City of Milton

ITB 2020.01 Hamilton Bridge – Upgrade of water Distribution

ADDENDUM #2 -

March 6, 2020

Sheet C002

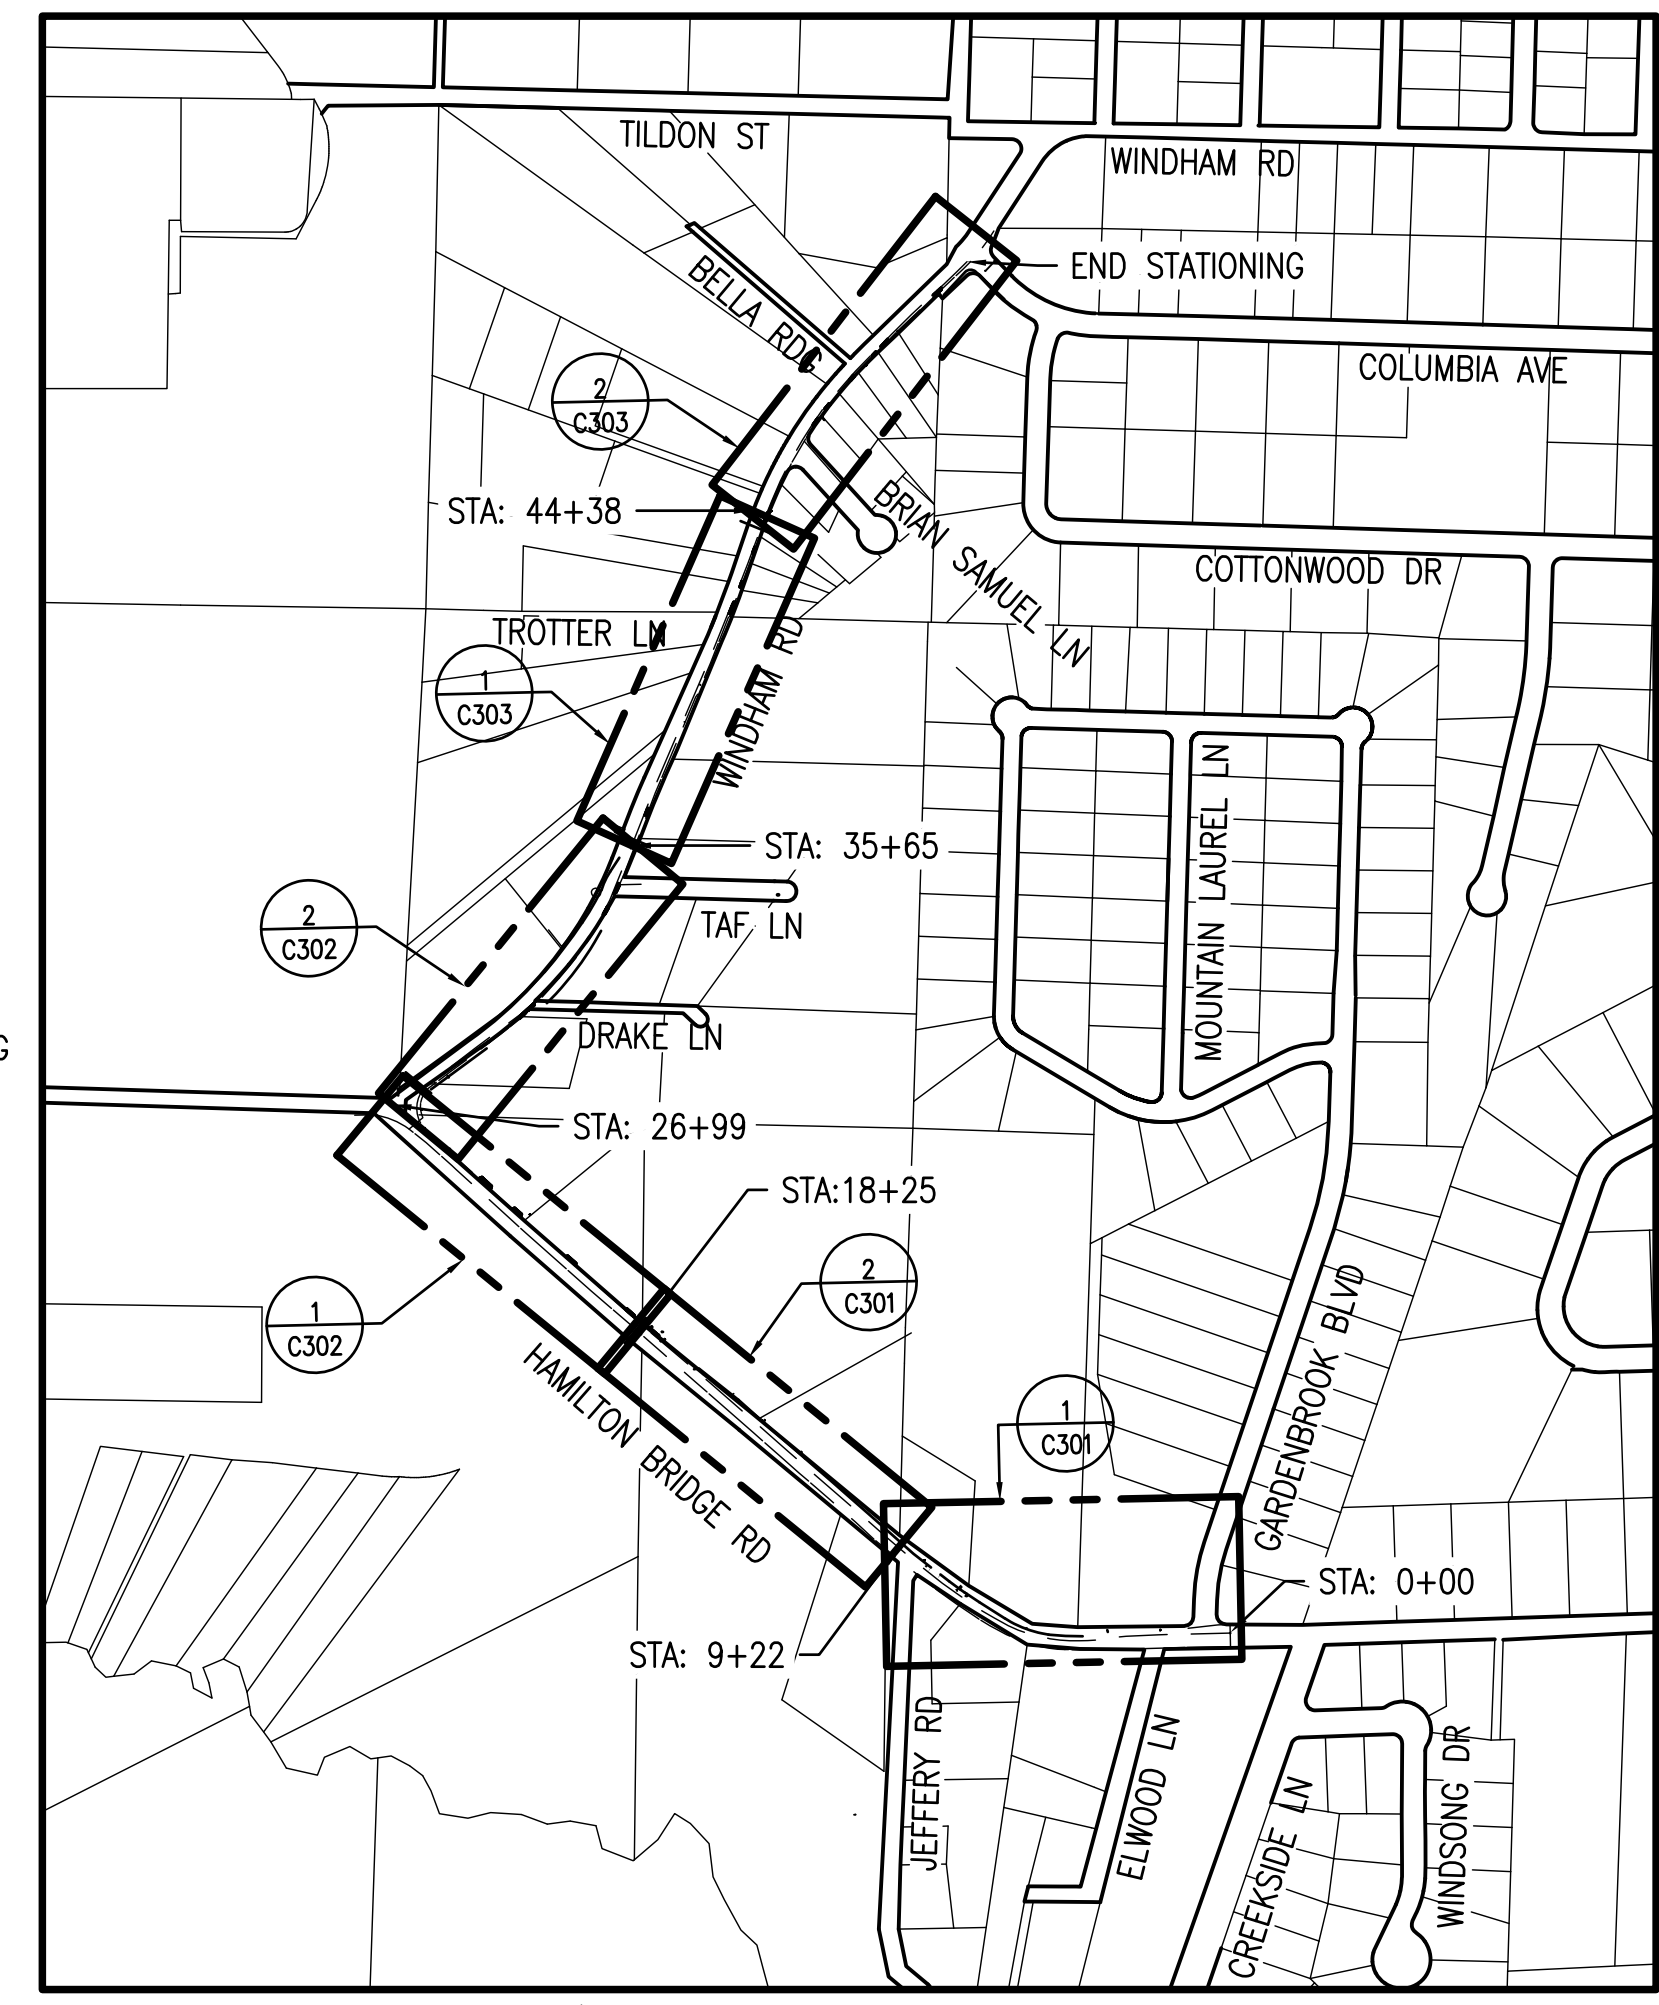
Revised Note 5 under heading "Utility Notes".

7. In the specifications, “marker balls” and the like are mentioned. Are they to be installed, or is tracing wire sufficient? Also, 002 note 5 references locating tape. Are we to install tape as well as wire?

Use tracer wire. Note on Sheet C002 is has been revised on Addendum No. 2 Plans.

DRAWN BY: AHH	DESIGNED BY: GMS	CHECKED BY: KCH	DATE: 2/4/2020
SCALE: 1" = 30'	NOT FOR CONSTRUCTION	BY:	DATE:
PROJECT NO: 2018-17	C301	SHEET: 3	OF 8

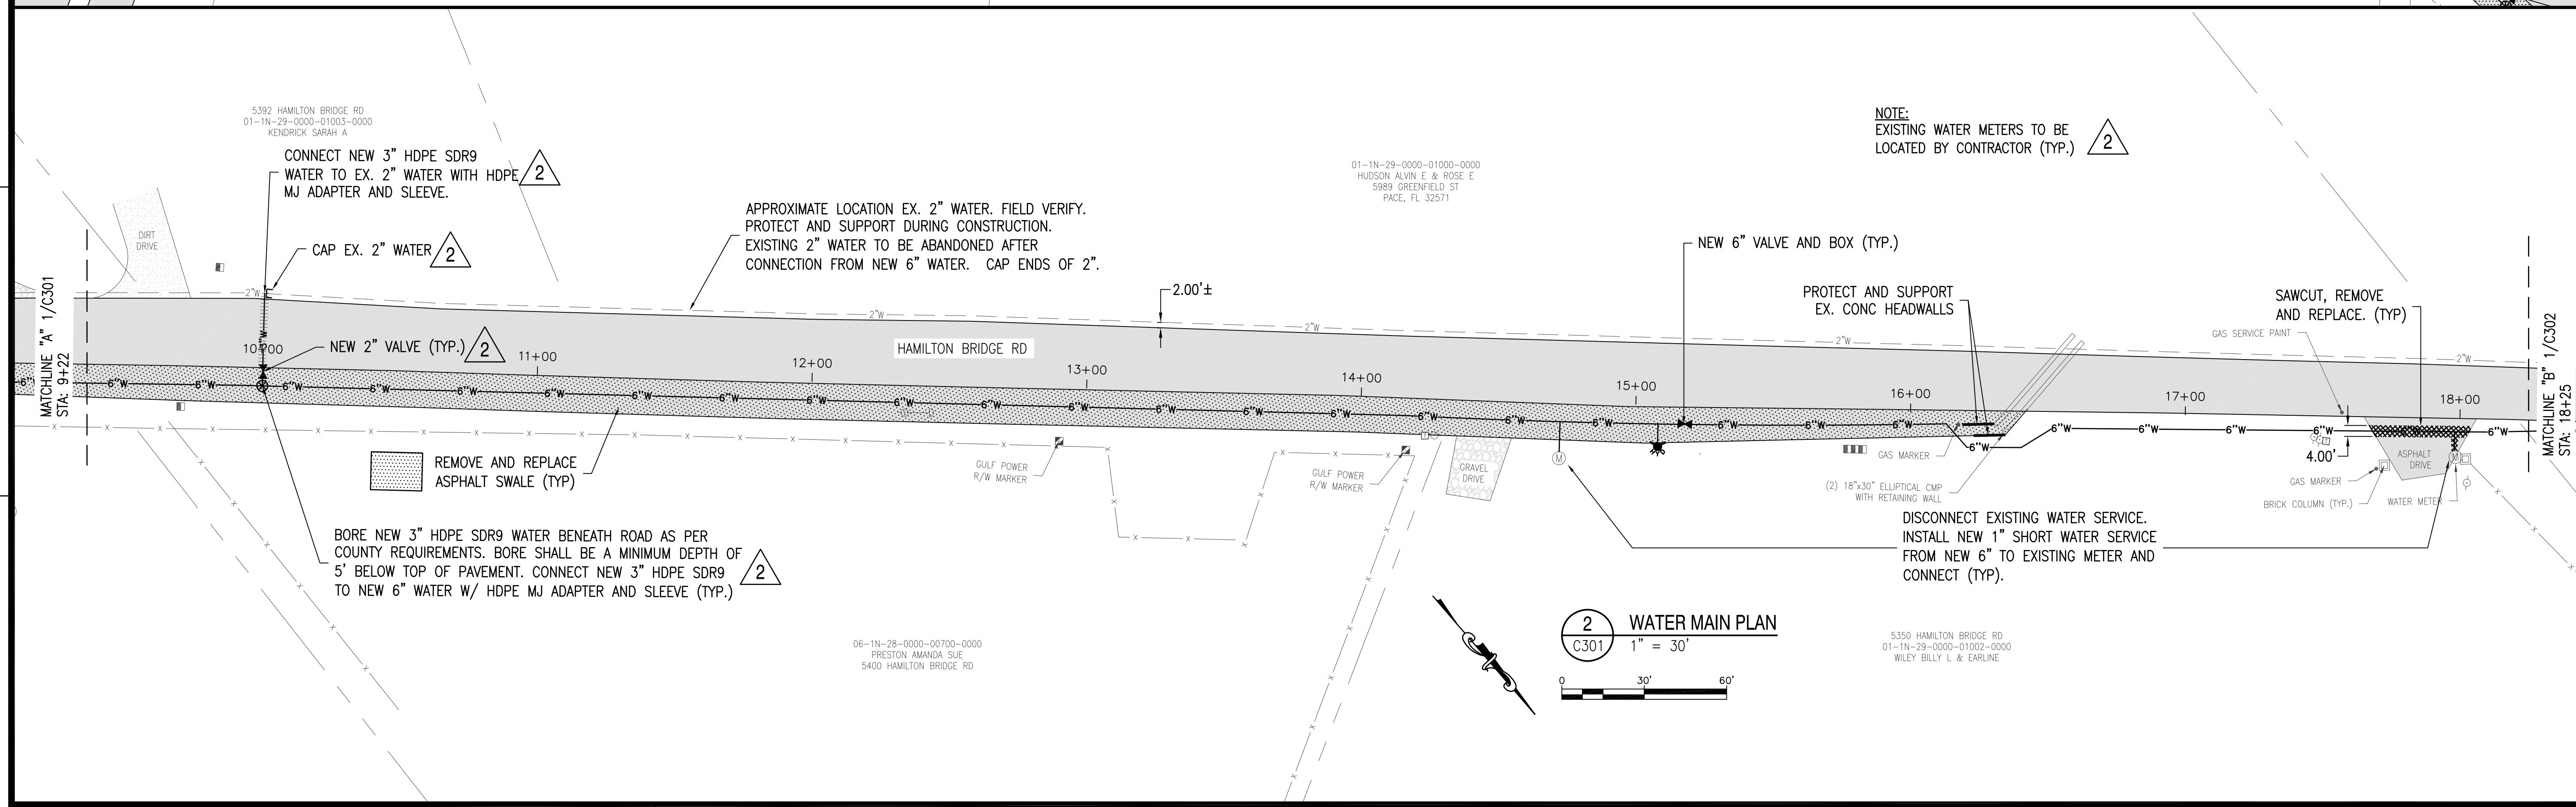
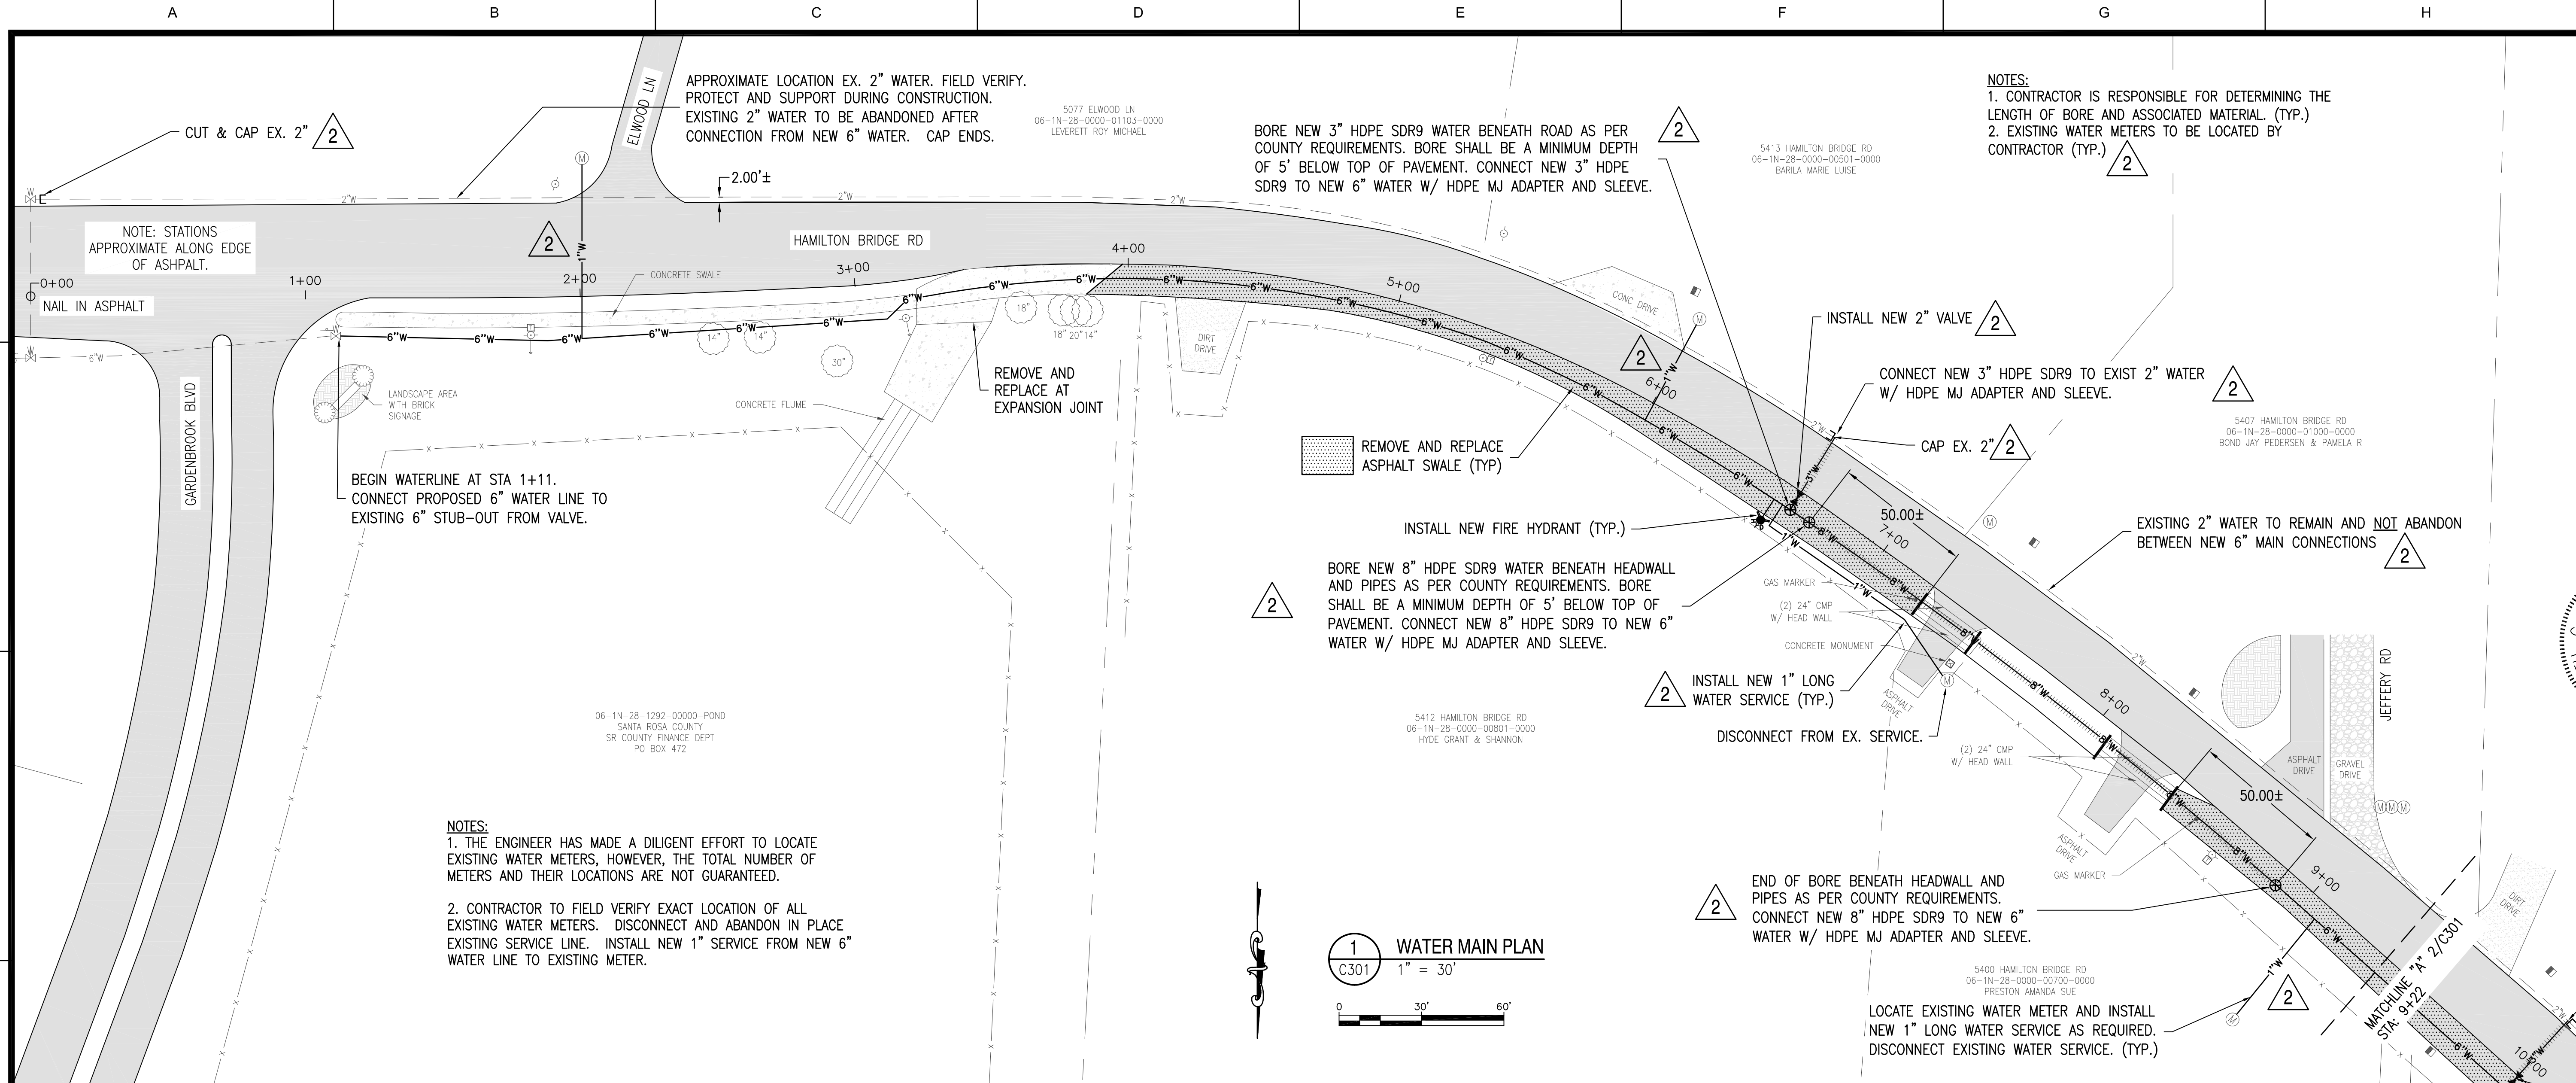
All water services to be 1 inch.

At Gardenbook Blvd, change existing 2" main to existing 6" main.

Change directional bores parallel to road, from 6" PVC to 8" HDPE, SDR 9. Connect with HDPE MJ Adapter and Sleeve.

Change directional bores across road from 6" PVC to 3" HDPE, SDR 9. Connect with MJ Adapter and Sleeve.

Added 2" valves and cut and cap.

Added 2" main to 6" main connections

3. There appear to be nine 6" water crossings on sheets 302 and 303. What do we do here? Terminate at the R.O.W. with a cap? On page 301, the same symbol is calling for it to be a 1" service. Maybe they are all 1" water services?

Plans have been revised to reflect that the 6" water crossings are 1" water services.
